BURLINGTON DEVELOPMENT REVIEW BOARD

AGENDA

TO: Development Review Board
FROM: Scott Gustin 
DATE: May 6, 2014
RE: 12-1138PD Amendment; 70 Appletree Point Lane

Request: Amend final plat approval to include minor site utility revisions, adjustment of farmhouse location on lot 20, retention & residing of existing storage shed, and provision of four standard house designs.

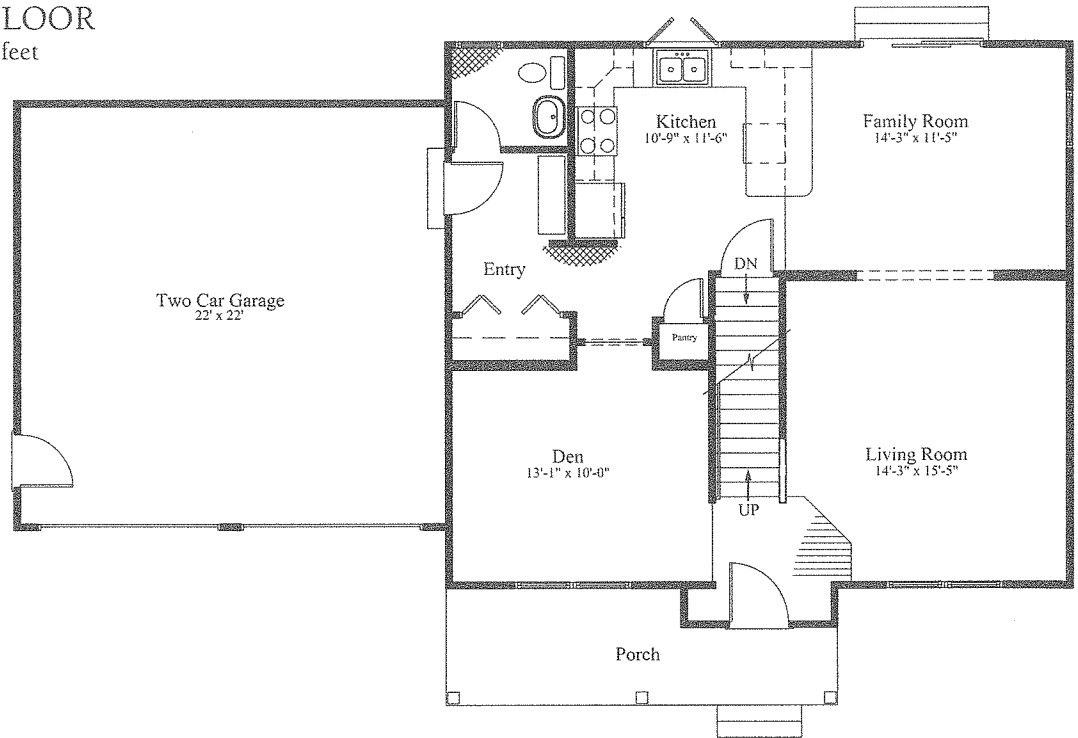
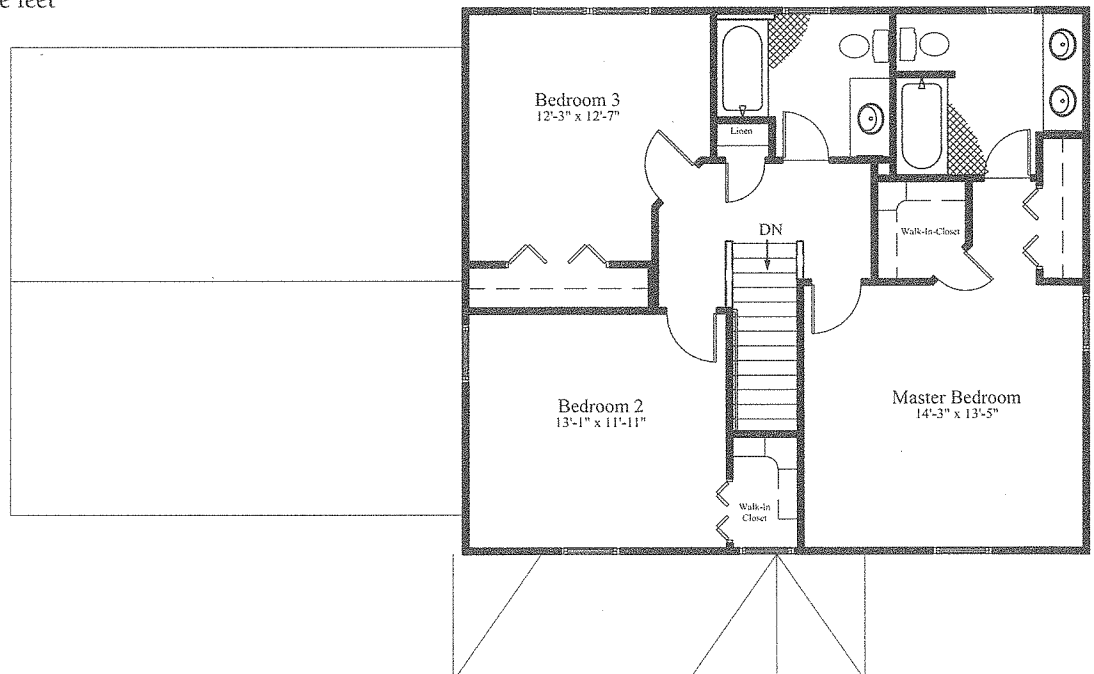
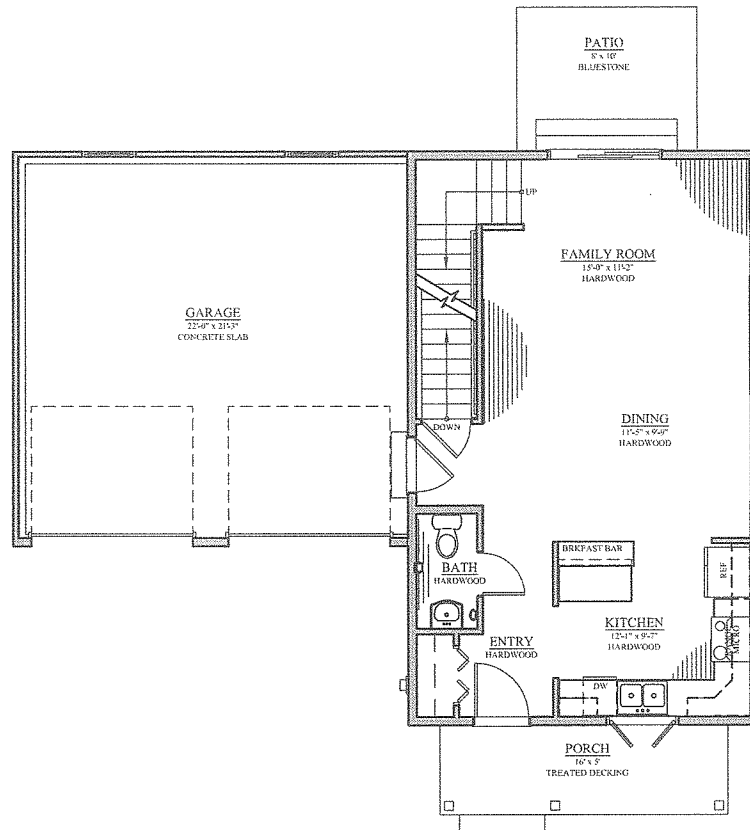
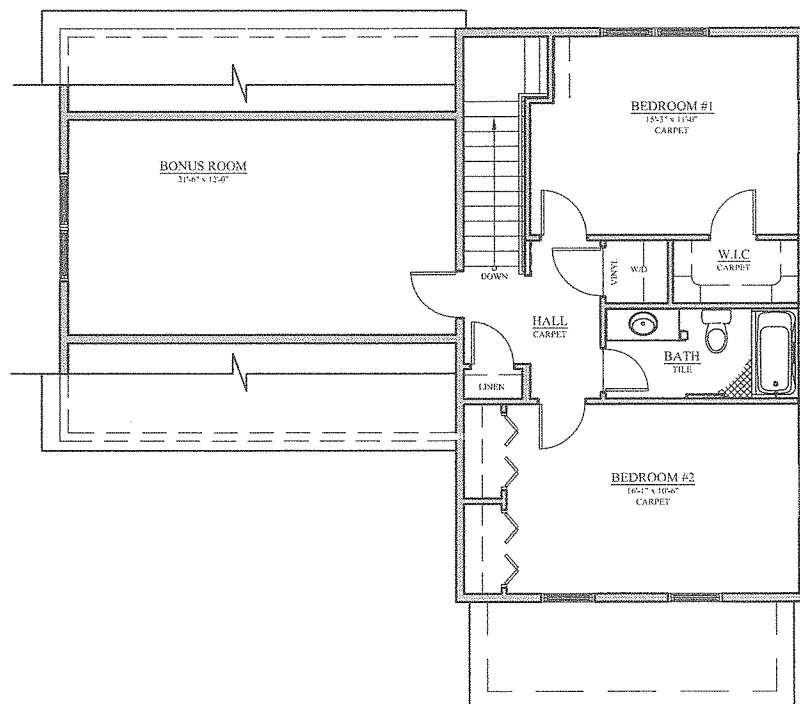
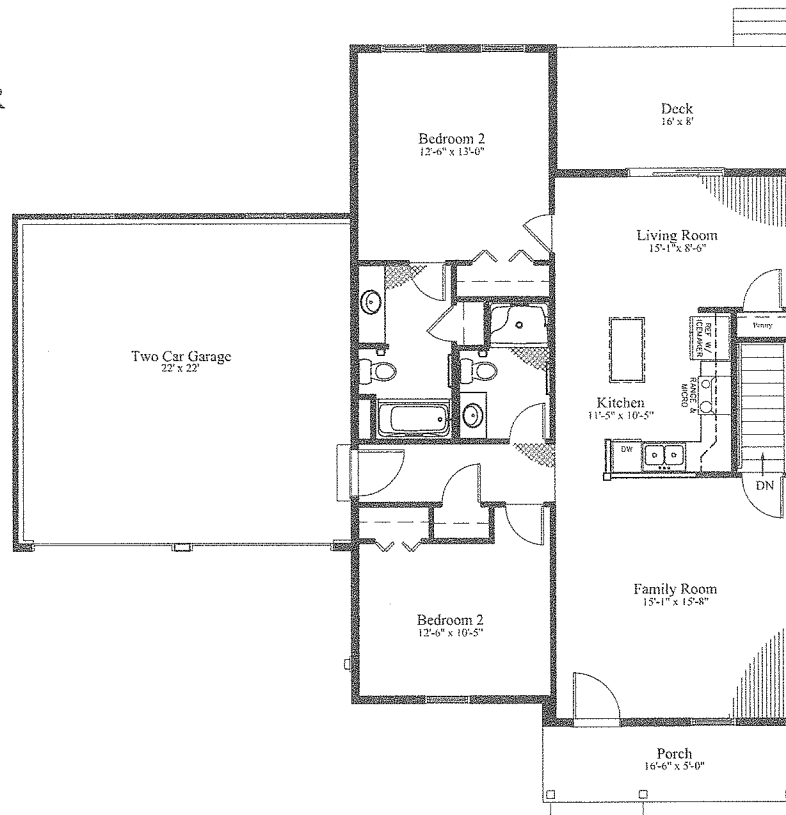
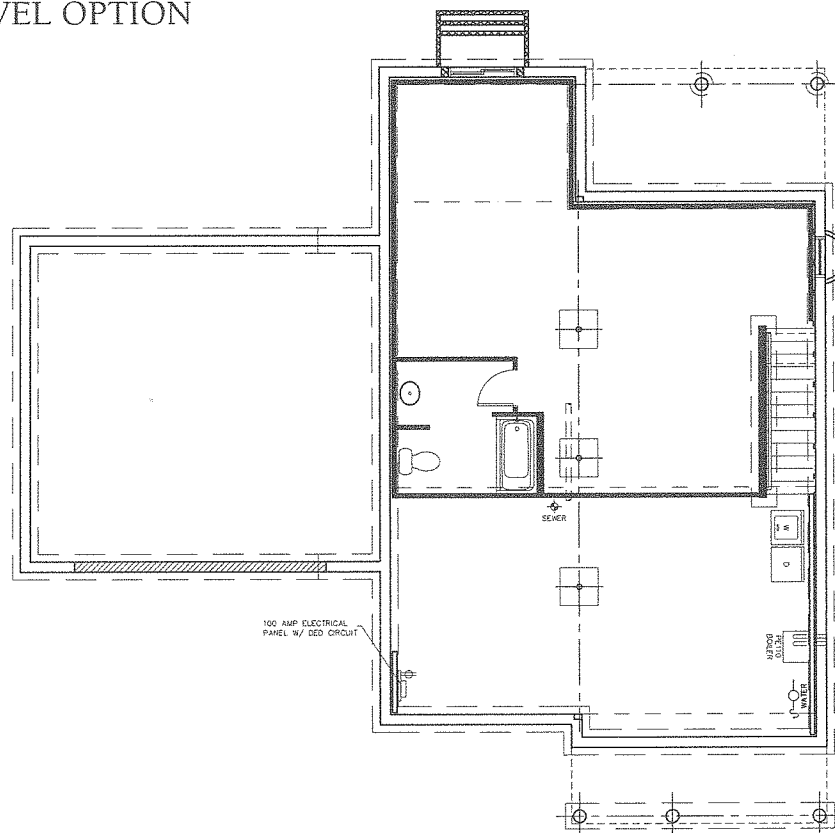
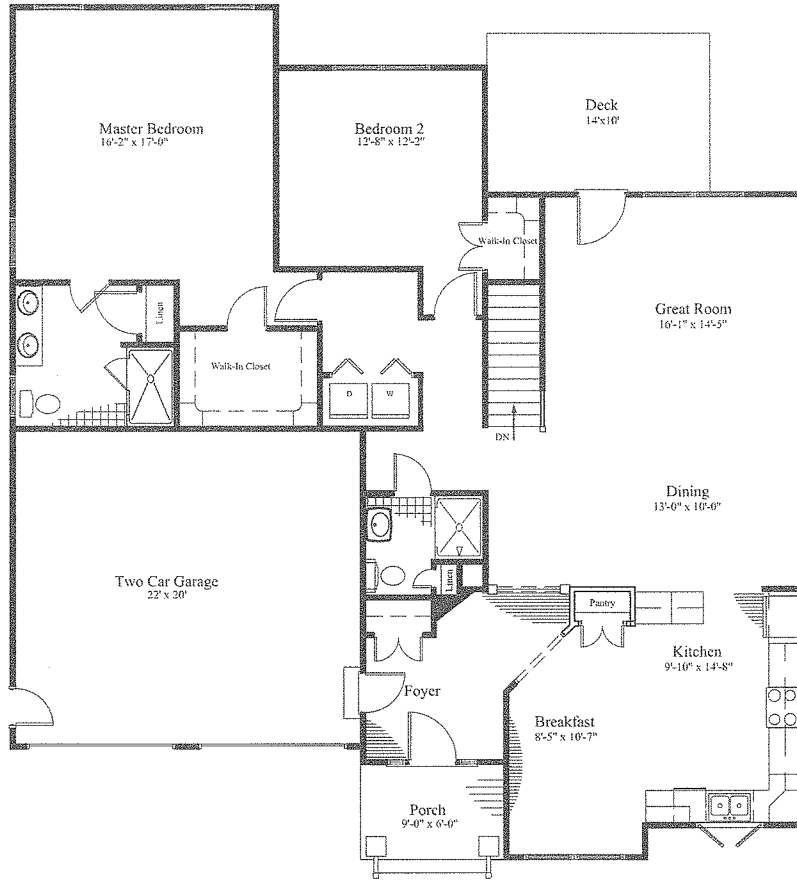
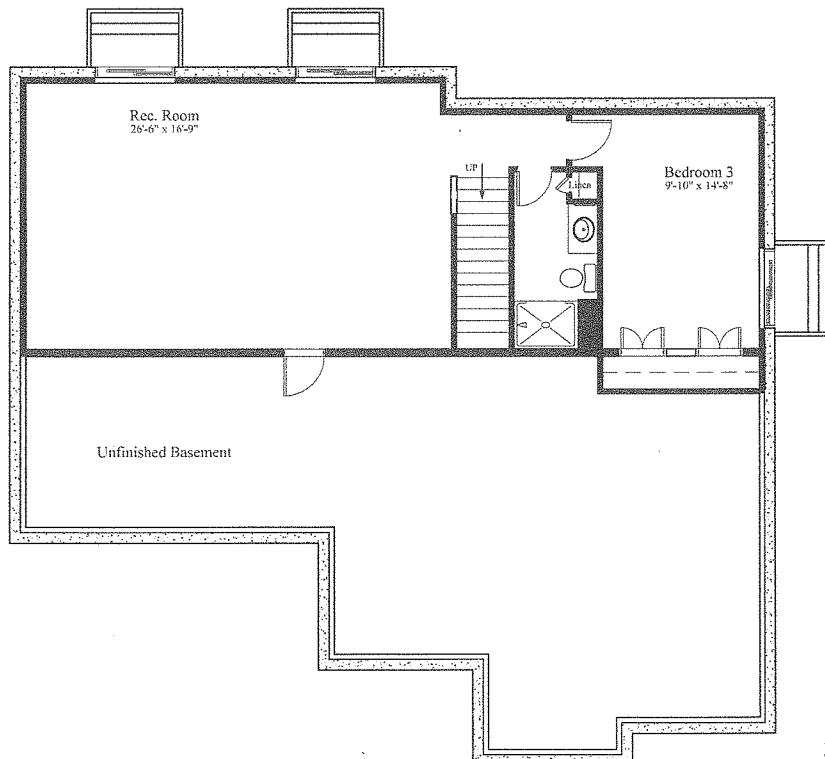
Mailbox and utility meter locations are not noted on the building templates. Mailbox locations were previously approved on posts by the road and may continue to be. If they are to be relocated onto the homes, the change must be noted. All utility meters must be on the sides or rear of the new homes and screened. **(Affirmative finding as conditioned)**

7. Zoning permit applications for the individual homes shall include scaled, detailed elevation drawings and site plans. As noted in this amendment, utility meters shall be located on the sides or rear of the homes and shall be screened. Only smooth or “brush stroke” vinyl siding may be installed. If any of the future houses substitute higher quality materials; such as wood or fiber cement siding or fiberglass, wood or wood clad windows; such materials are acceptable substitutes for the lower quality less desirable materials proposed.
8. Standard permit conditions 1 -15.

DRAWING NUMBER:
C3.1

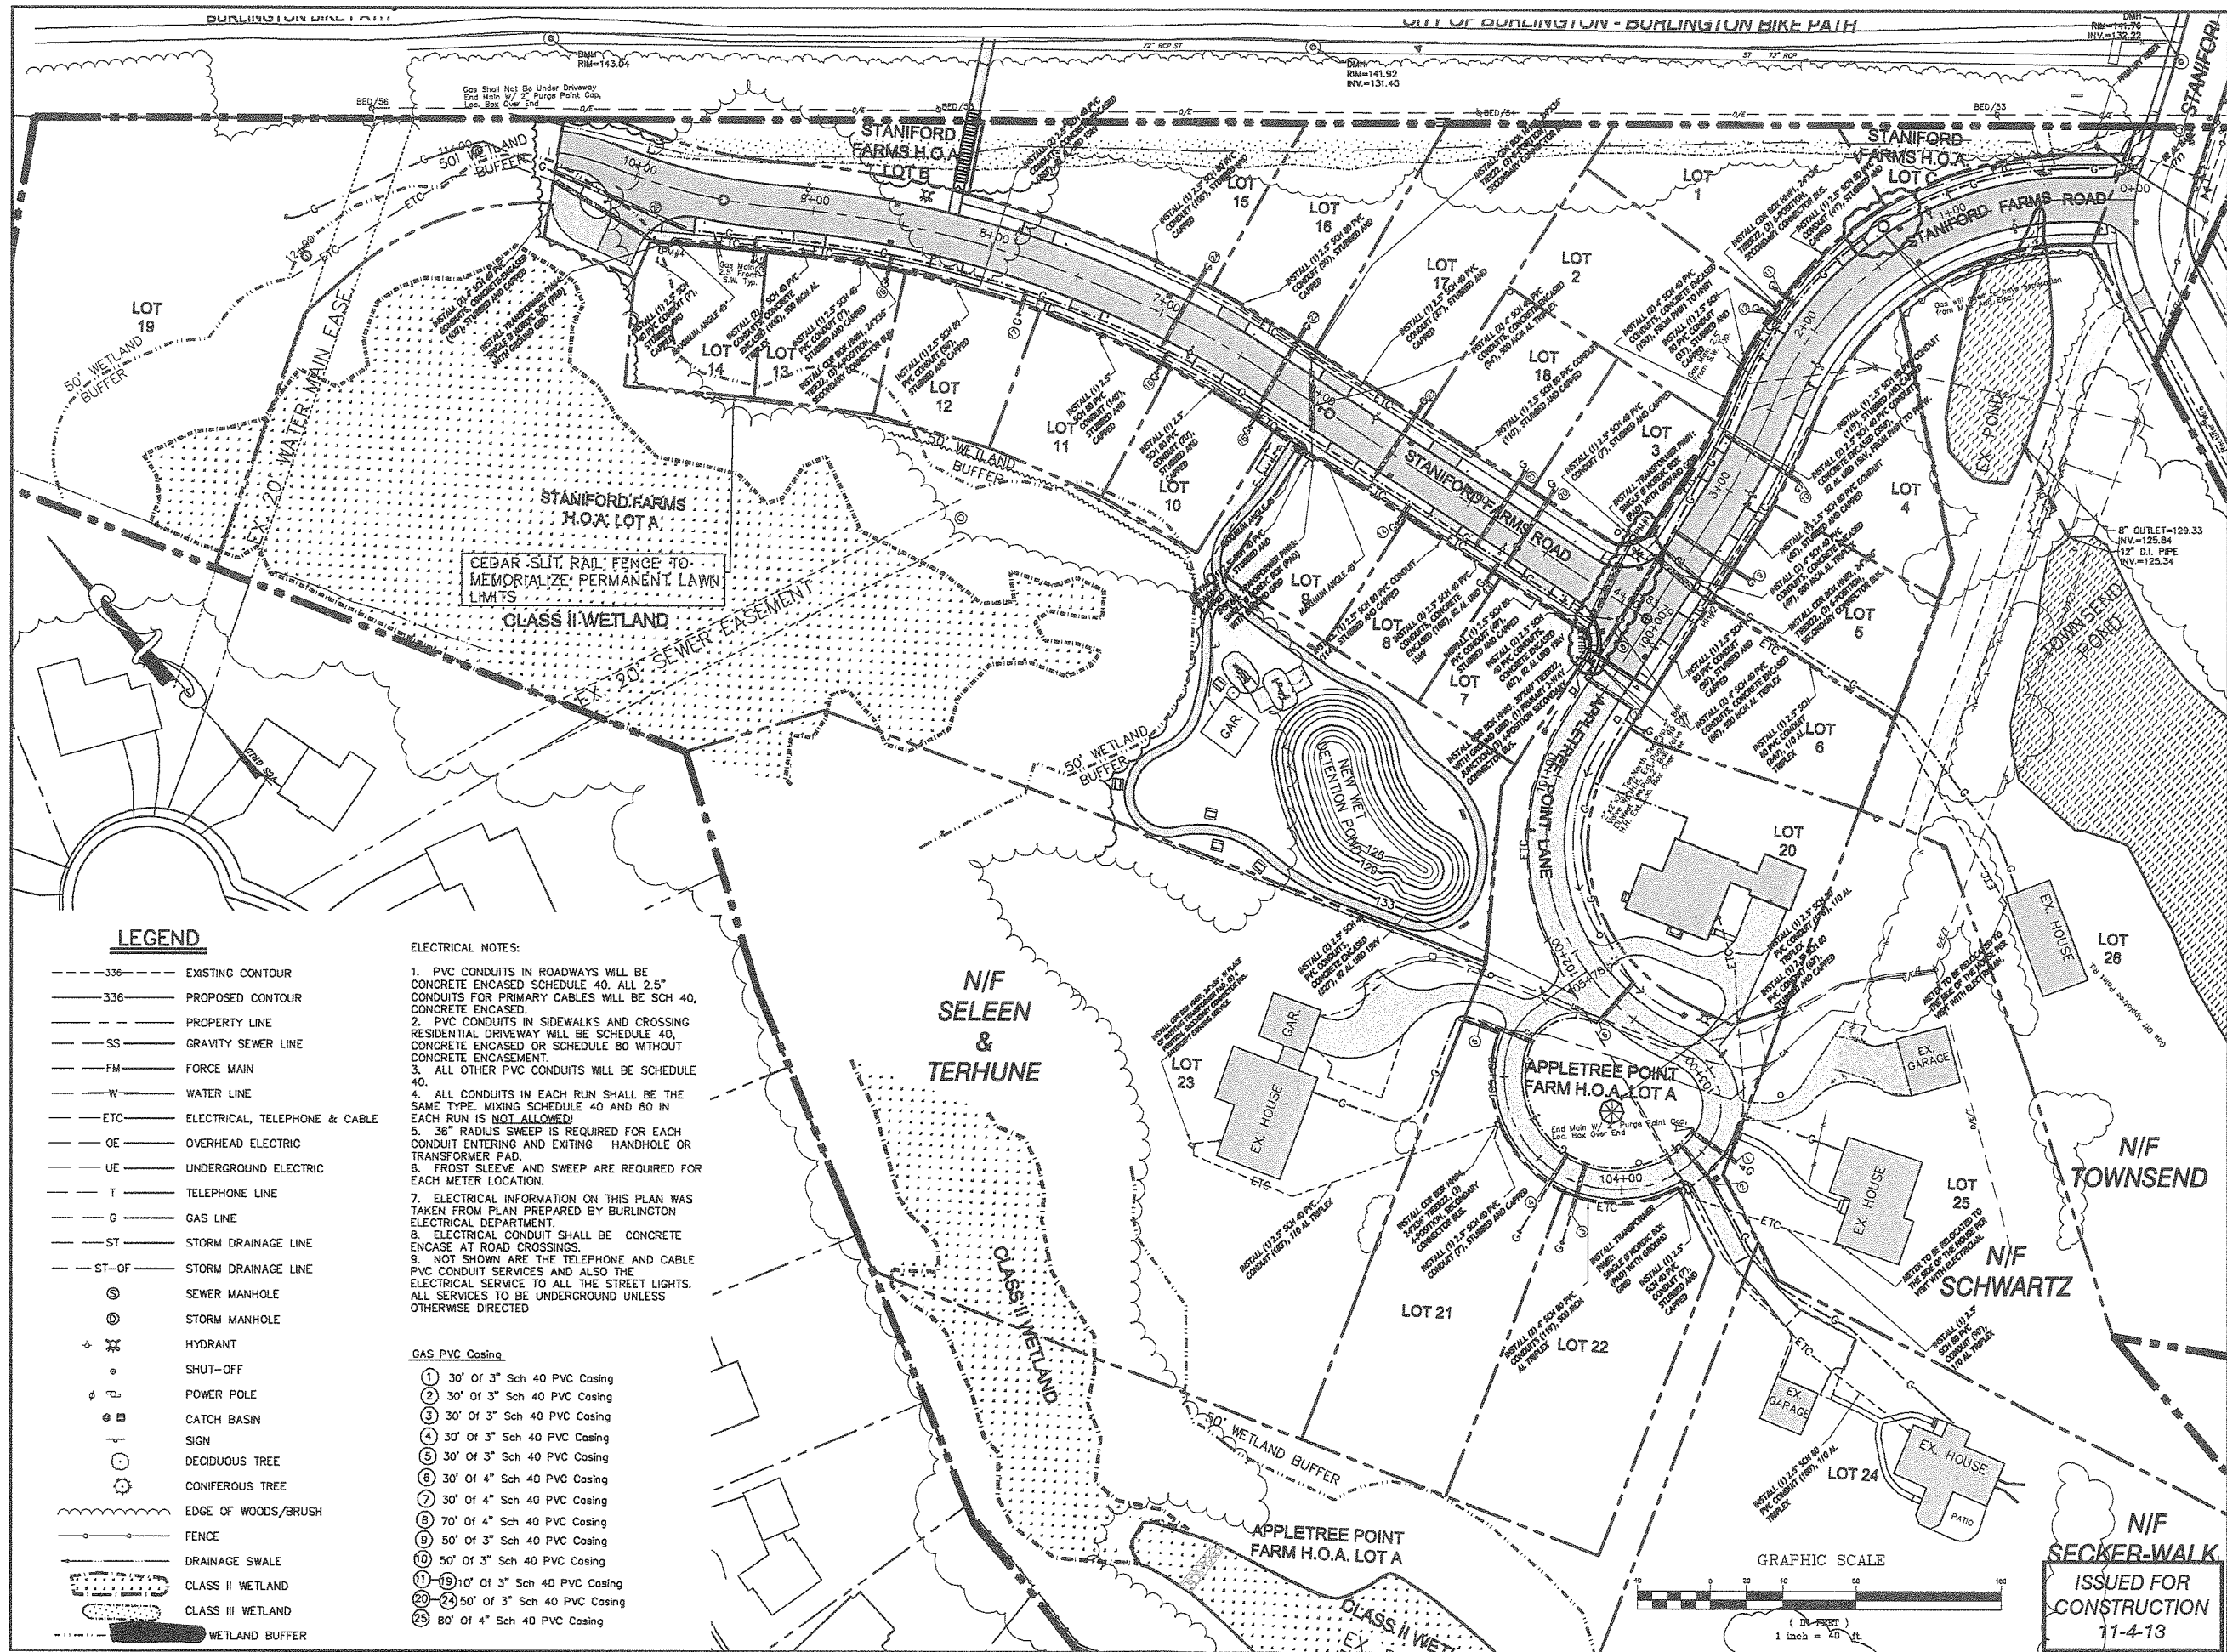
Project infrastructure remains largely unchanged except that utility lines will be laid out to provide greater separation distances than originally proposed. **(Affirmative finding)**
